TENDER 7119-KP-21 - Addendum #4

Project: Elmira District S.S. - Window, Roof, HVAC & Sanitary Upgrades

Project Name:	Elmira District Secondary School – Window, Roof, HVAC and Sanitary Upgrades	Date Issued:	March 25, 2021
Quasar Project #:	ED-20-300		
Client Project #:	20931		
Addendum #: M-1 Revision #: 0

Project Name:	Elmira District Secondary School – Window, Roof, HVAC and Sanitary Upgrades	Date Issued:	March 25, 2021
Quasar Project #:	ED-20-300		
Client Project #:	20931		
Addendum #: E-1 Revision #: 0

M-105

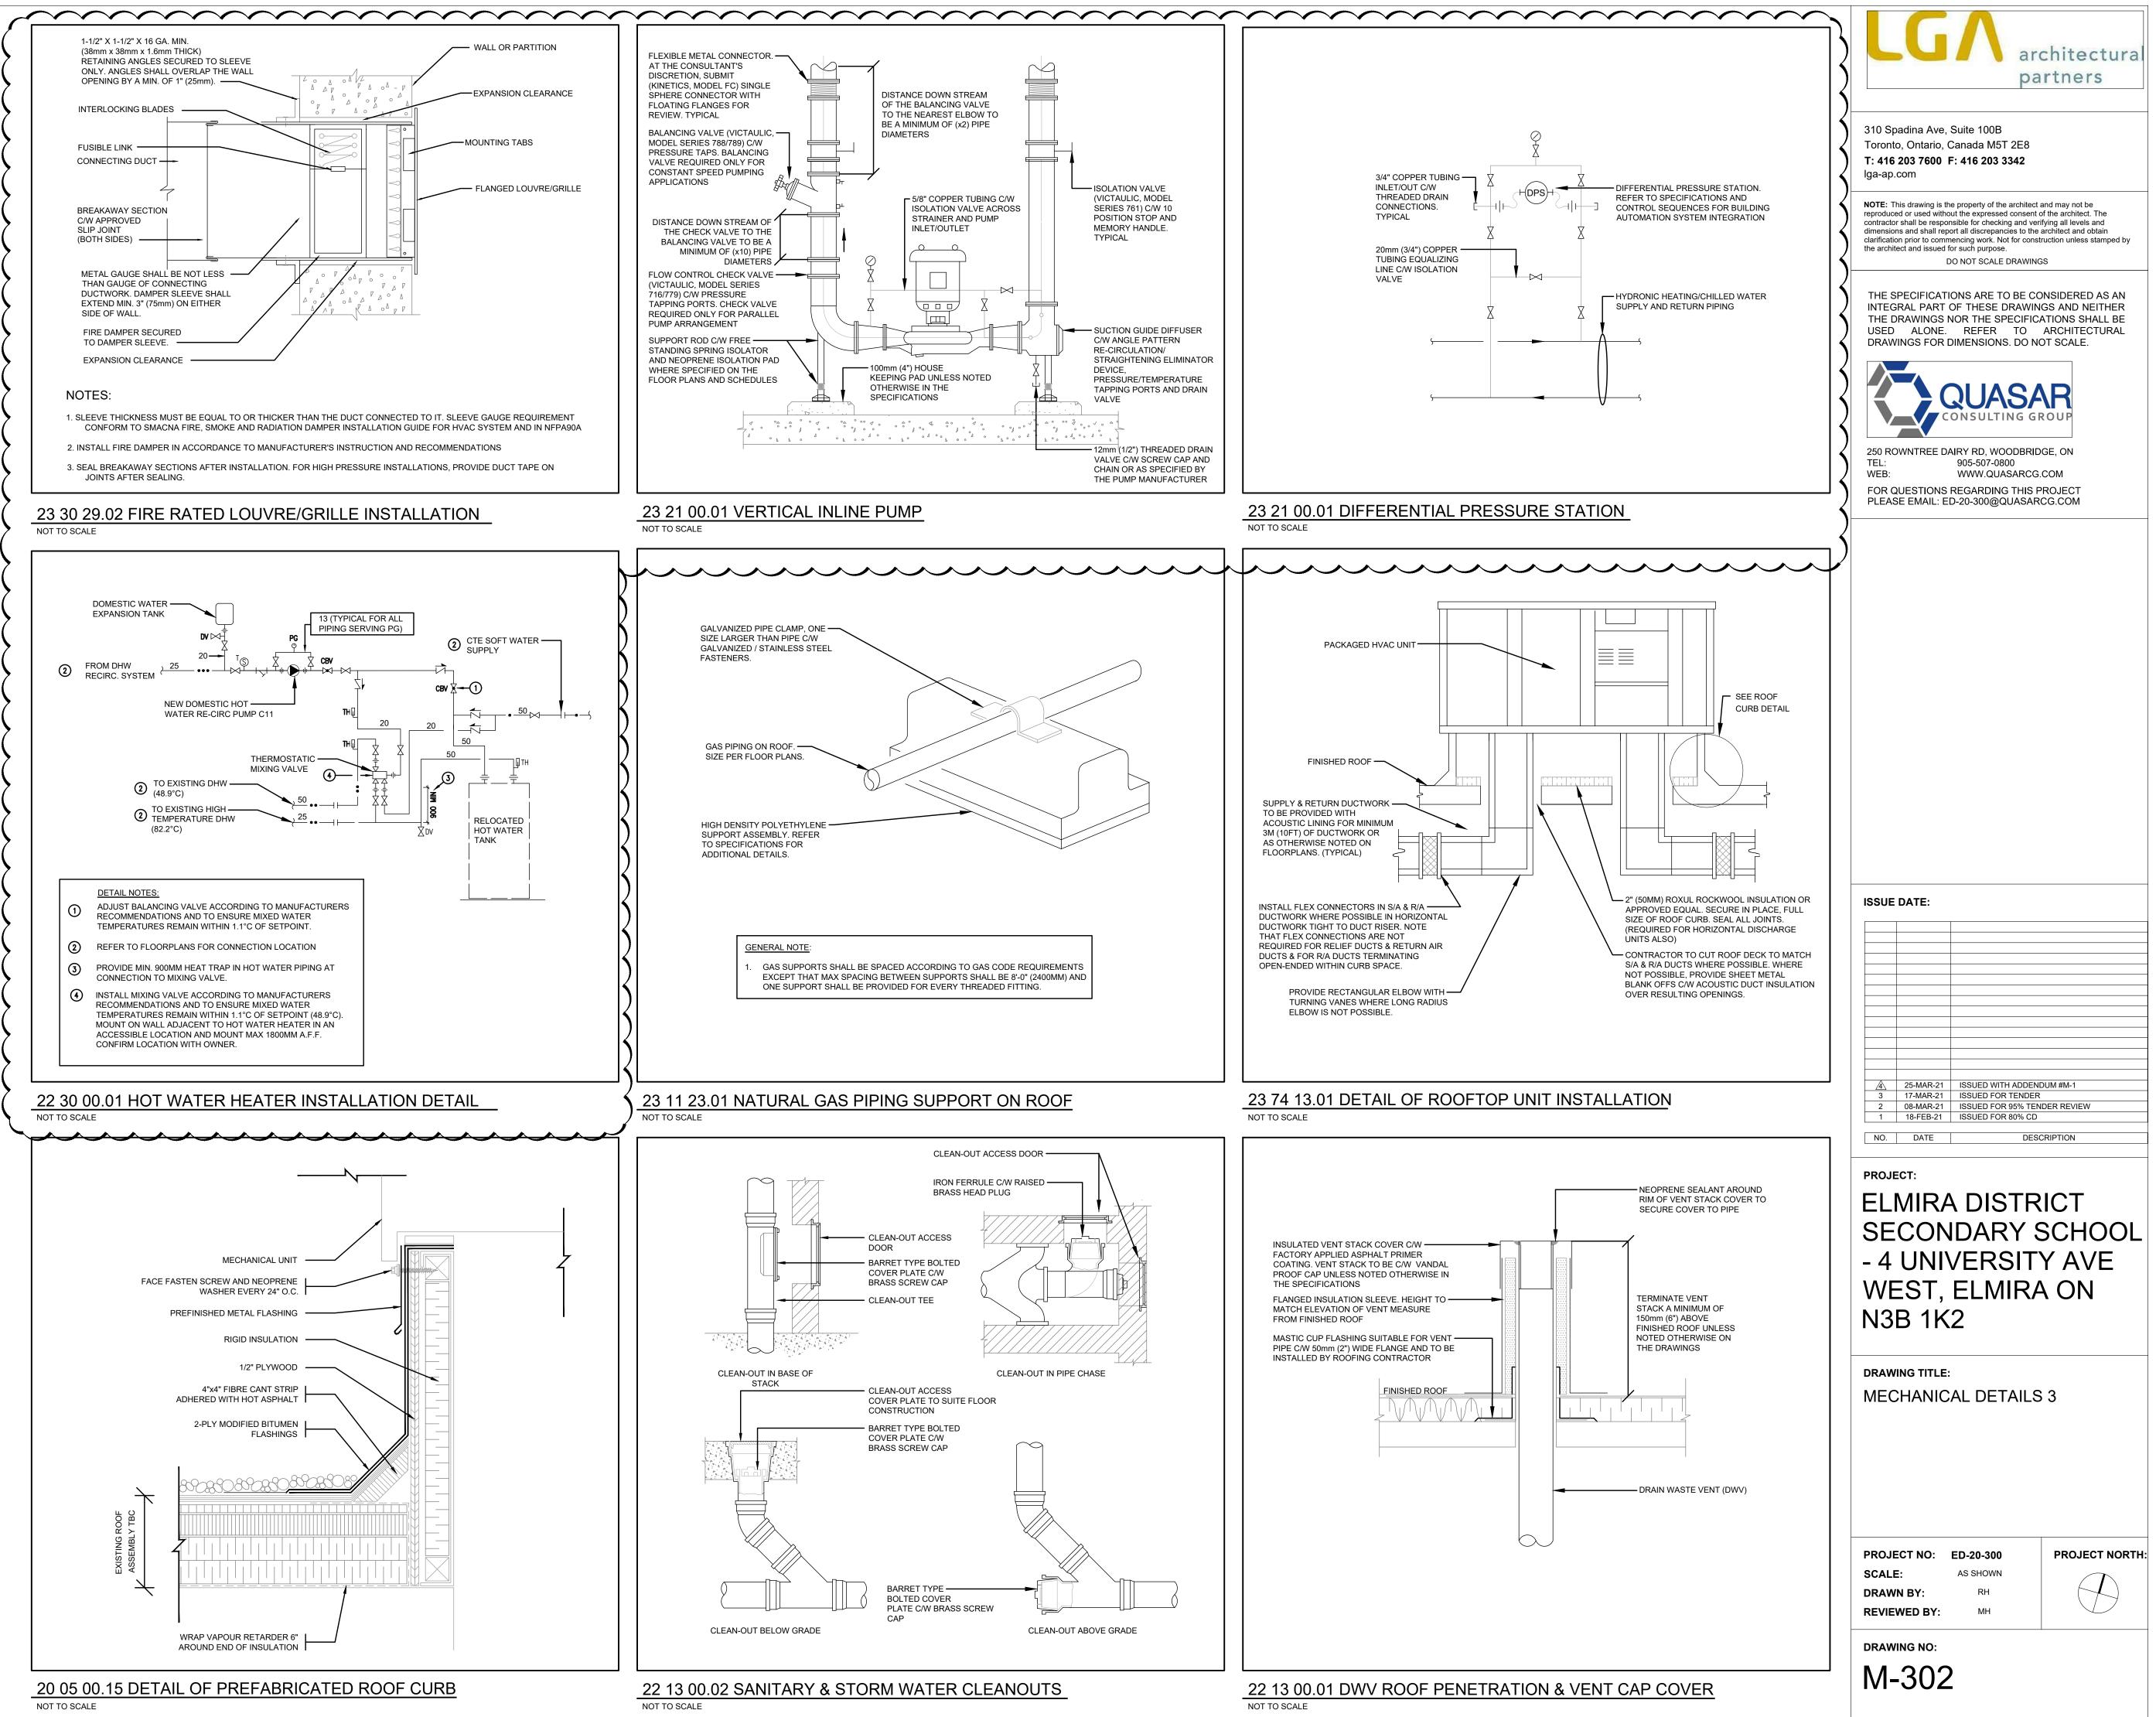
5. DRAWING M-105 – HVAC PIPING – GYM - DEMO AND NEW WORK PLAN

a. Addition of heating water piping to differential pressure sensor as shown.

ELECTRICAL LEGEND AND DRAWING LIST

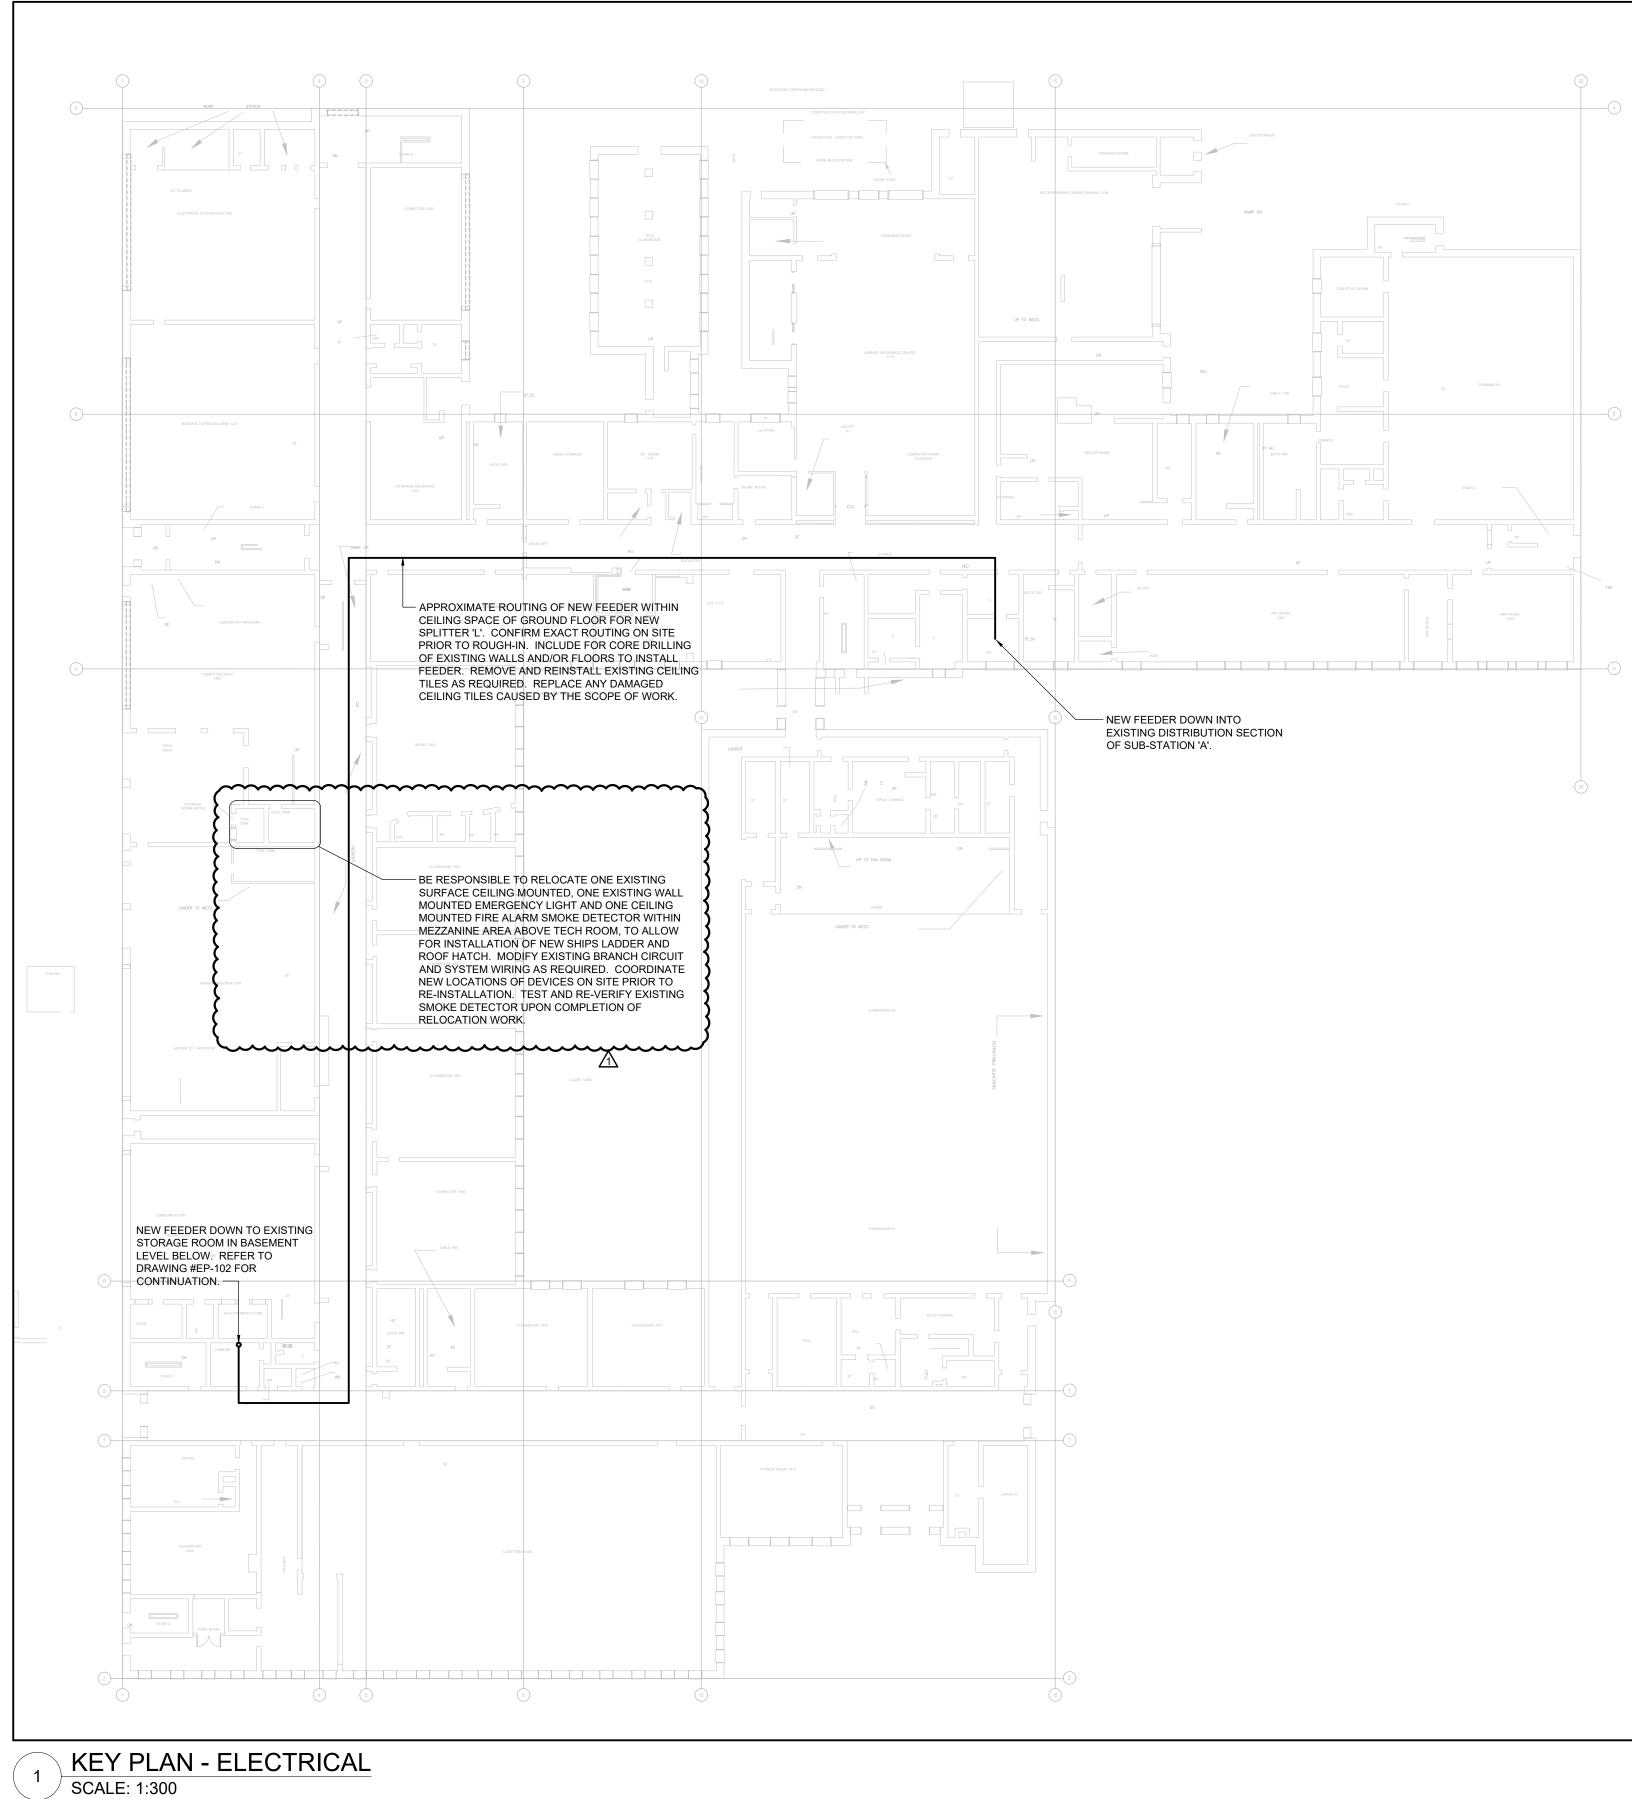
1. DRAWING EA-001 – ELECTRICAL LEGEND AND DRAWING LIST (ISSUED HEREWITH)

a. Refer to key plan on this drawing and provide work associated with relocation of existing ceiling mounted light fixture and smoke detector and wall mounted emergency light to accommodate new roof hatch and vertical ships ladder.

CAFETERIA DEMOLITION PLAN - LIGHTING SCALE: 1:100

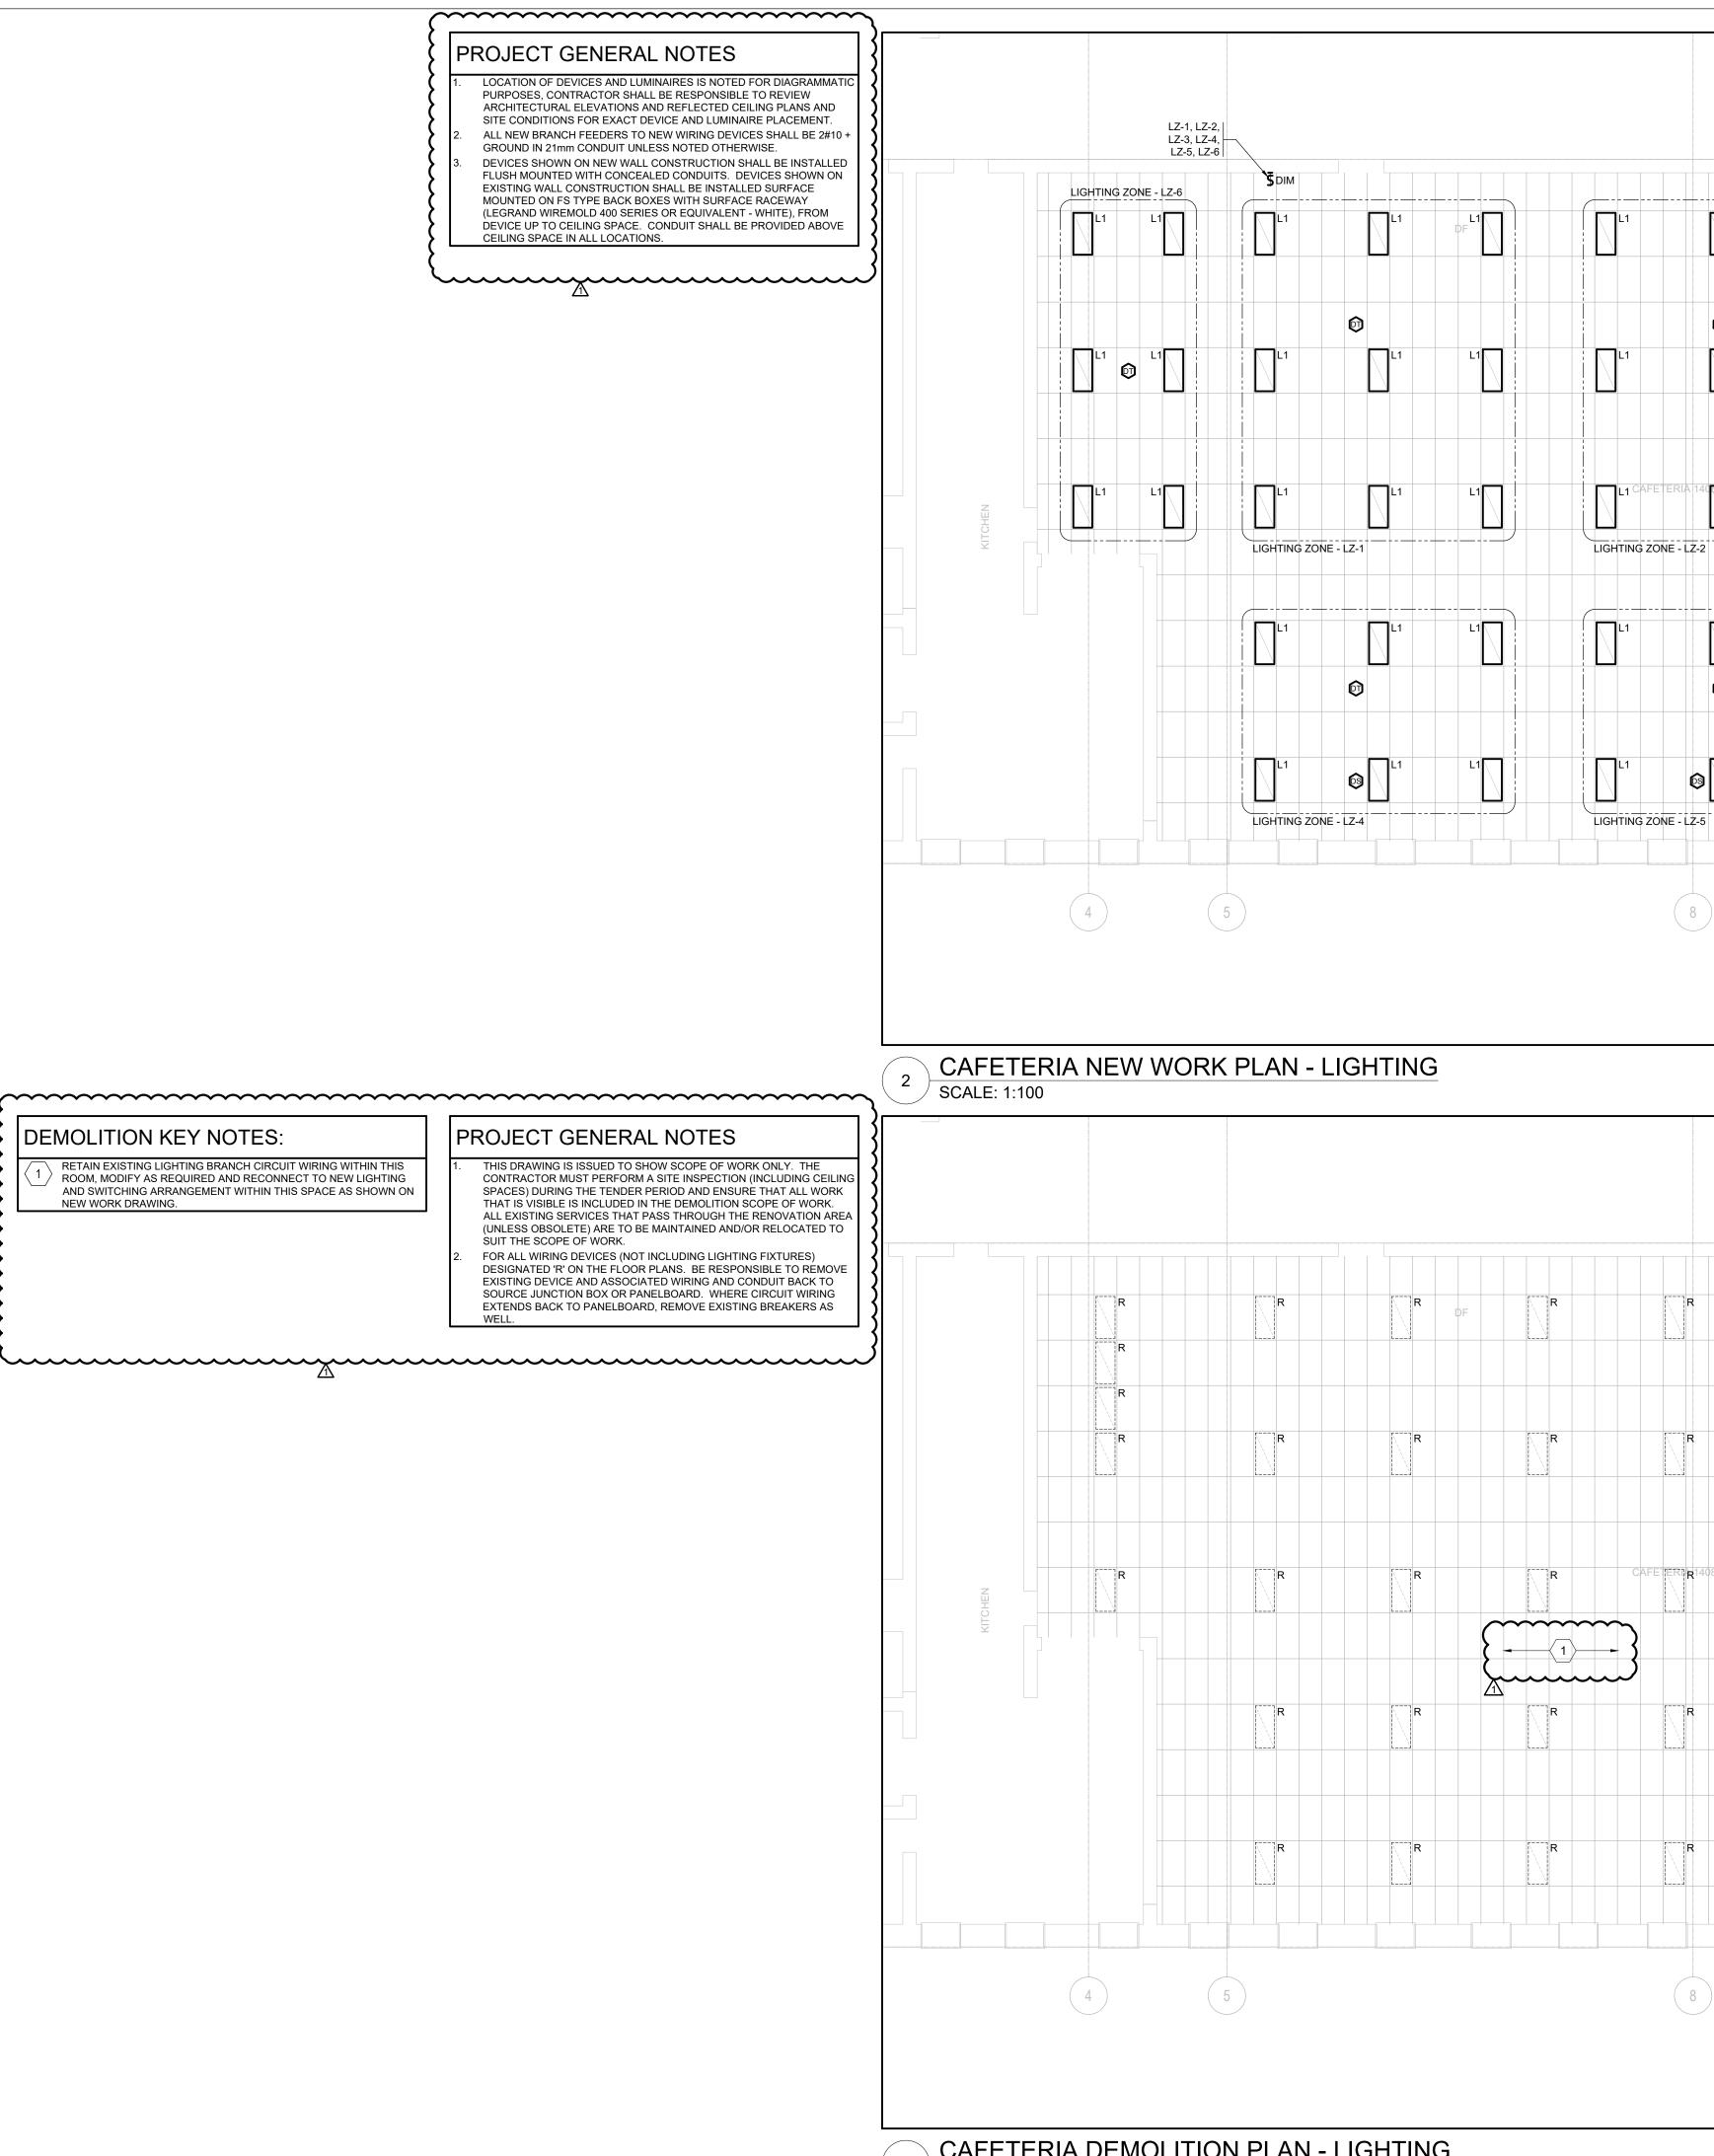
2. DRAWING EL-101 - CAFETERIA LIGHTING PLANS (ISSUED HEREWITH)

a. Refer to attached, revised drawing EL-101 and note addition of drawing general and key notes for both demolition and new work plans.
